APICAL INDUSTRIES, INC.
dba DART AEROSPACE

ENGINEERING CHANGE NOTICE NO.

07030

DWG NO. 645.6200

SHEET 1, FRONT VIEW WAS:

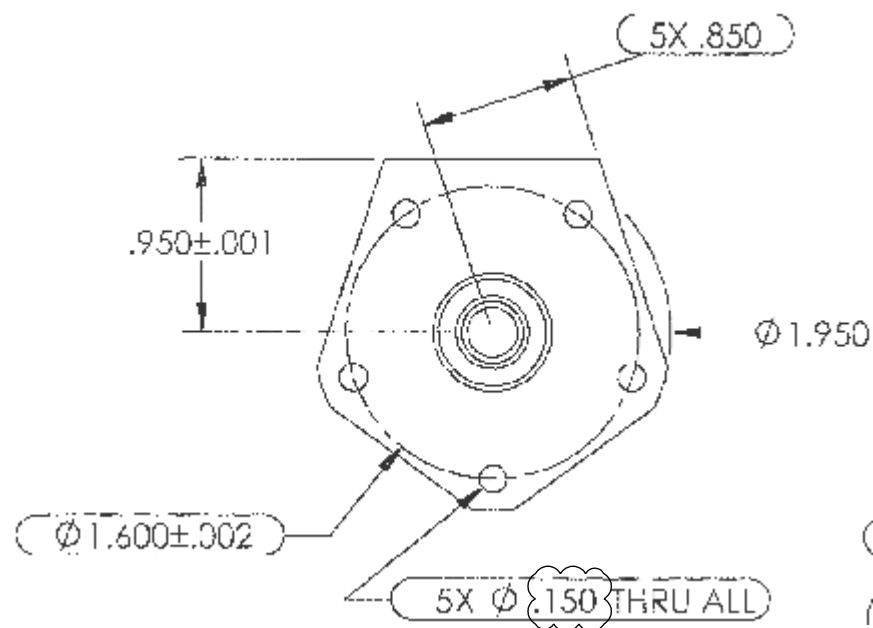
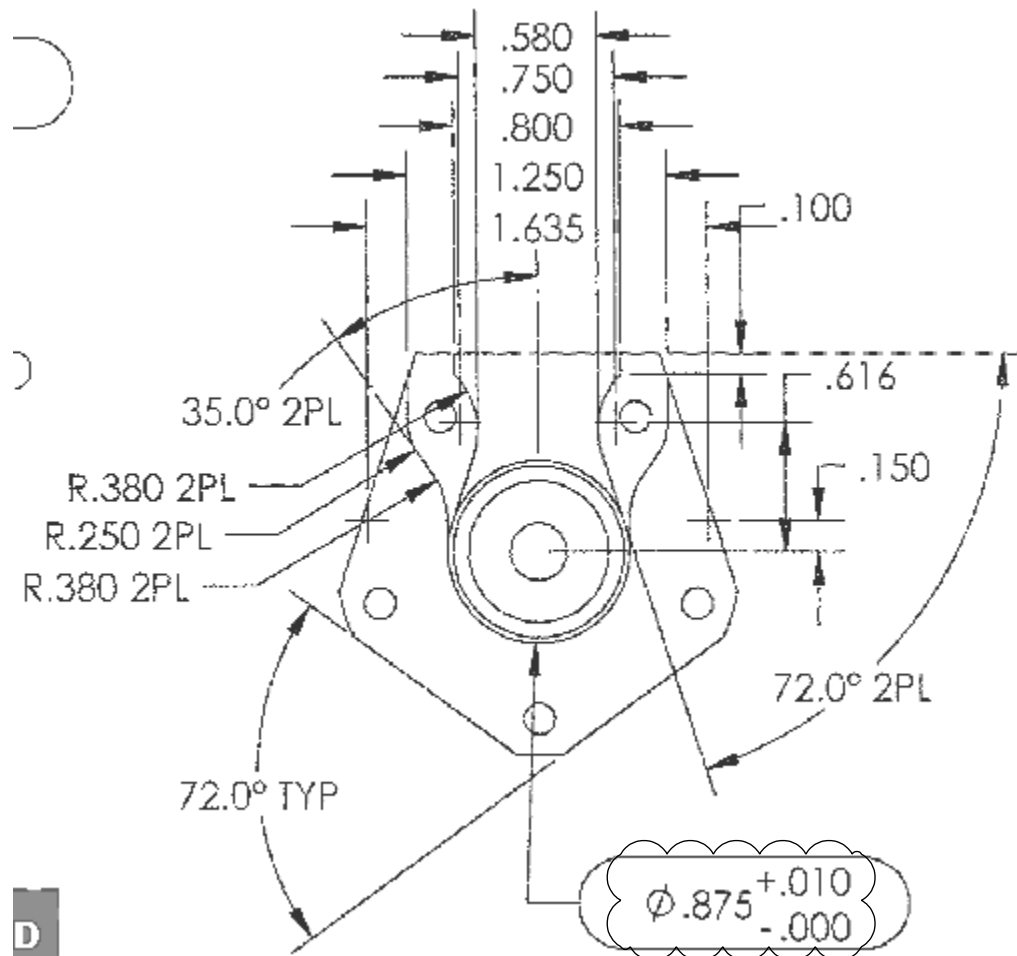
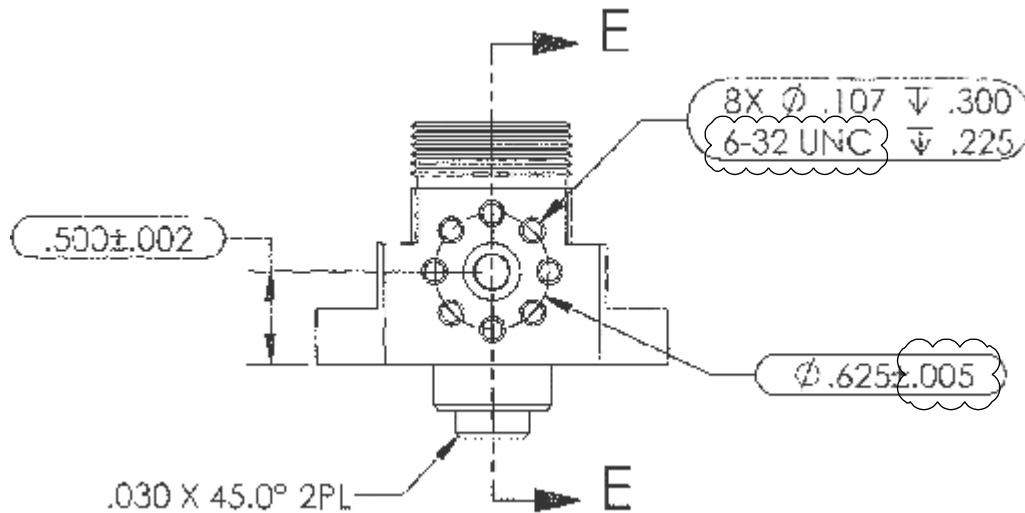
REASON: REVISED TEMPLATE AND VIEWS FOR CLARITY. REVISED NOTES. REVISED TRIGGER BALL AND TRIGGER PISTON BORE.
ADDED SURFACE ROUGHNESS VALUES AS RADII (FOR MACHINING) AS REQUIRED.

SHEET 1, LEFT HAND VIEW WAS:**SHEET 1, RIGHT HAND VIEW WAS:**

SHEET 1, TOP VIEW WAS:**SHEET 1, SECTION E-E:**
